APPEAL SUMMARY		
Status: Decision Rendered		
Appeal ID: 16063	Project Address: 1711 SE 48th Ave	
Hearing Date: 11/1/17	Appellant Name: Toni King	
Case No.: B-012	Appellant Phone: 503-235-2573	
Appeal Type: Building	Plans Examiner/Inspector: Preliminary	
Project Type: residential	Stories: 2 Occupancy: R-3 Construction Type: V-B	
Building/Business Name:	Fire Sprinklers: No	
Appeal Involves: Alteration of an existing structure	LUR or Permit Application No.:	
Plan Submitted Option: pdf [File 1] [File 2] [File 3] [File 4] [File 5]	Proposed use:

APPEAL INFORMATION SHEET

BASEMENT REMODEL FOR:

1711 SE 48TH AVENUE

Attachments (4 sheets): Proposed basement plan. Existing stair plan and section. Construction Notes Proposed stair plan & section.

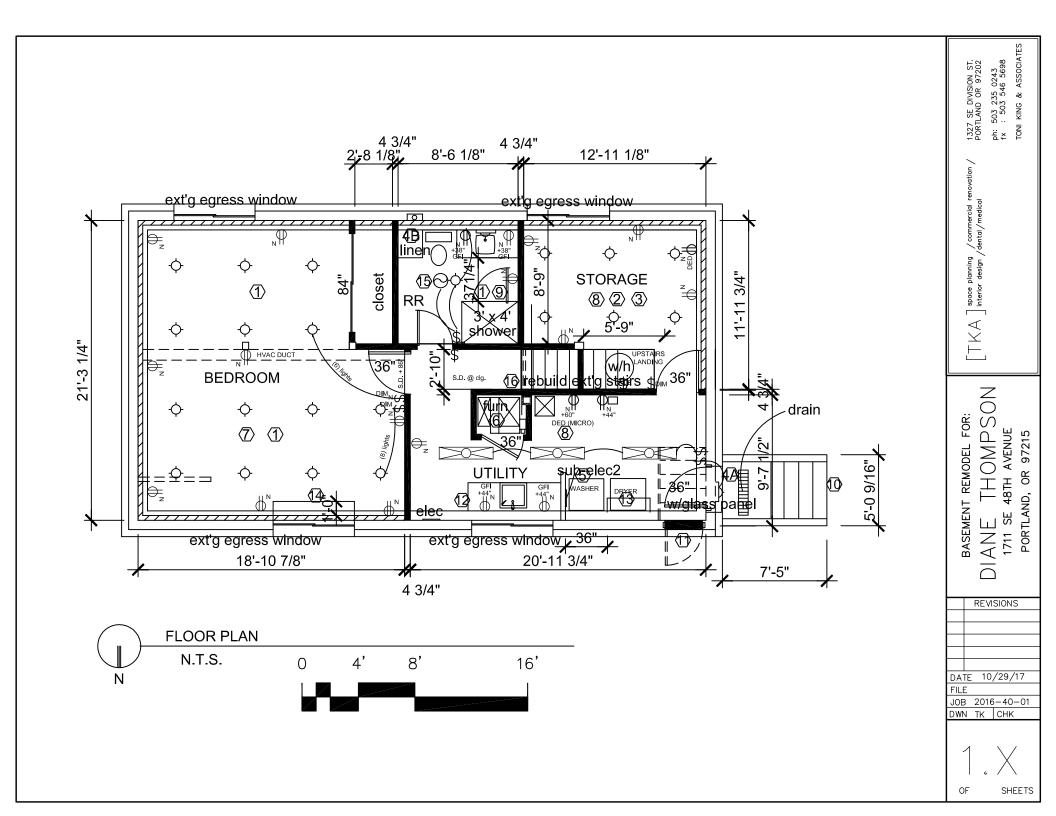
Code Section	ORSC R311.7 Stairs (and ORSC Appendix J Existing Buildings)				
Requires	R311.7.1 Width. Stairways shall not be less than 36" in clear width.				
	R311.7.2 Headroom. The minimum headroom in all parts of the stairway shall not be less than 6'-8".				
	and				
	AJ501.1 Newly constructed elements. Newly constructed elements, components and systems				
	shall comply with the requirements of this code.				
Proposed Design	Proposed Design: (Describe the alternate methods or materials of construction to be used or that				
	exist. Be as specific as possible)				
	The proposed basement remodel is adding as new set of exterior stairs to the basement through				
	the backdoor which will be completely code compliant. This appeal addresses the internal existing				
	stairs, which after remodel are not required for exiting at all. The basement will have a completely				
	legal egress through the exterior stairs and egress windows will also be added as part of the remodel.

The owner would like to keep the concept of the internal stair for convenience purposes.				
	The existing stairs have 7-3/4" risers and 9" treads (measured nose to nose). The existing width is				
	currently 34". Headroom currently is only 5'-9 ¾ to 6'-4 3/4.				
	By re-building the stairs to the basement, one riser can be eliminated and the riser height is still				
	less than 9" (8-5/8"), but the tread width is improved to 10-5/16" (meeting the 9" minimum				
	requirement). A winder will be built at the landing.

The proposed design is as follows for the basement stairs:

9" maximum riser, 9" minimum tread length. (8 5/8" rise and 10-5/16" tread).

A minimum of 6'-2" headroom will remain. Actual headroom 6'-3" to 7'-0".

Stair width will remain 34".

Existing stair reconstructed to meet Brochure #9 to remain in addition to new code compliant exterior stair: Granted as proposed.
